Project	IEEE 802.16 Broadband Wireless Access Working Group < http://ieee802.org/16 >	
Title	Congestion control mechanism for interworking between WLAN and WMAN	
Date Submitted	2004-01-05	
Source(s)	<p>Marc Engels Flanders' MECHATRONICS Technology Centre (FMTC) Celestijnenlaan 300D B-3001 Leuven Belgium</p> <p>Peter Coenen IMEC Kapeldreef 75 B-3001 Leuven Belgium</p> <p>Christian Hoymann Bernhard Walke Communication Networks Aachen University Kopernikus Str. 16 D-52074 Aachen Germany</p>	<p>Voice: +32 16 32 25 90 Fax: +32 16 32 29 84 marc.engels@fmtc.be</p> <p>Voice: +32 16 28 87 23 Fax: +32 16 28 86 50 peter.coenen@imec.be</p> <p>Voice: +49 241 80 27954 hoy@comnets.rwth-aachen.de</p>
Re:	Call for contribution IEEE 802.16d-03/83	
Abstract	This contribution proposes an enhancement to the service flow change mechanism	
Purpose	For inclusion in the 802.16-REVd_D2 amendment document	
Notice	This document has been prepared to assist IEEE 802.16. It is offered as a basis for discussion and is not binding on the contributing individual(s) or organization(s). The material in this document is subject to change in form and content after further study. The contributor(s) reserve(s) the right

Figure 21—MAC SAP event and MAC event sequence for temporary traffic reduction stimulated by CS

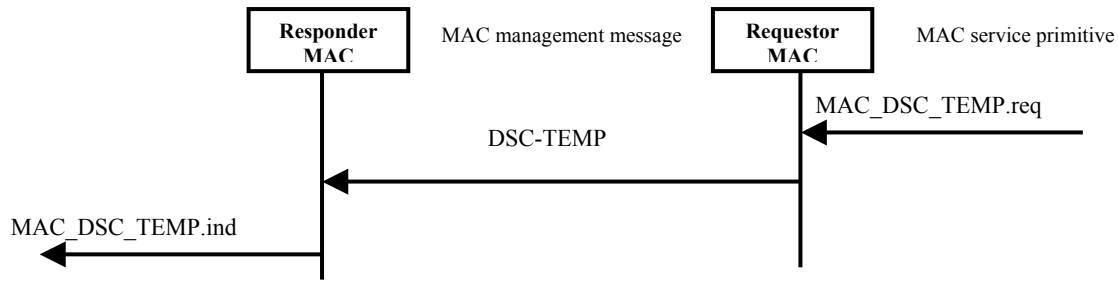
Add new text line 27 p.44

The sequence of logical MAC SAP events and the associated actual MAC events effecting a CS stimulated temporary traffic reduction are shown in Figure 21.

Figure 125 - DSC-TEMP mechanism

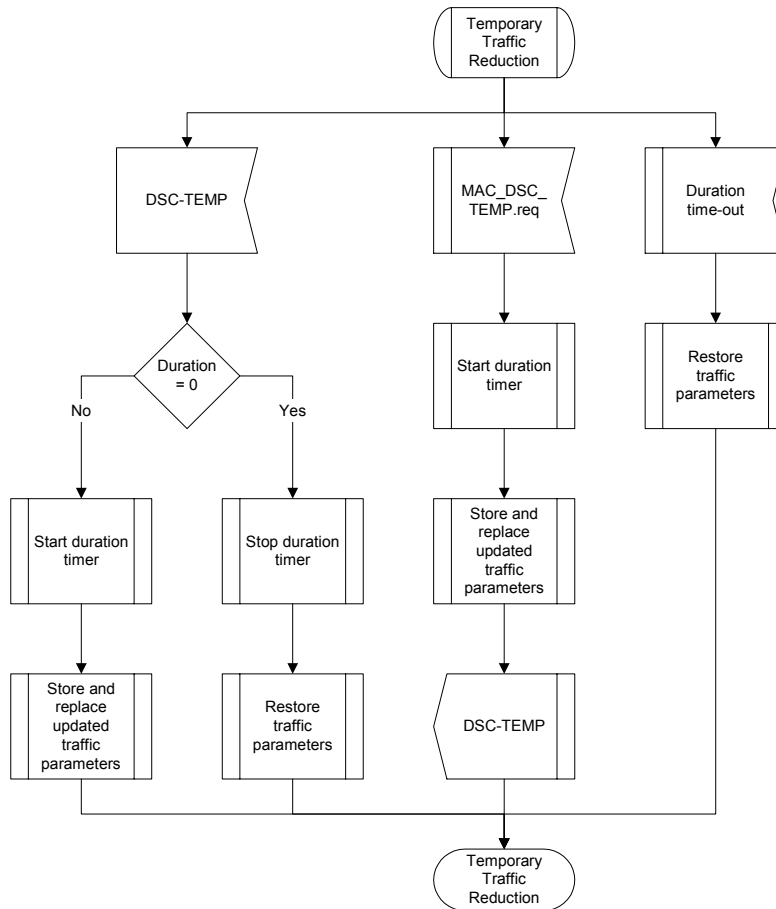
Add on page 250 line 31 the chapter below :

6.4.13.10.6 Temporary traffic reduction

The temporary traffic reduction mechanism is a fast, low overhead mechanism, which realizes a temporary traffic reduction for the concerned transport connection.

Figure 125 shows the State Transition diagram for this mechanism.
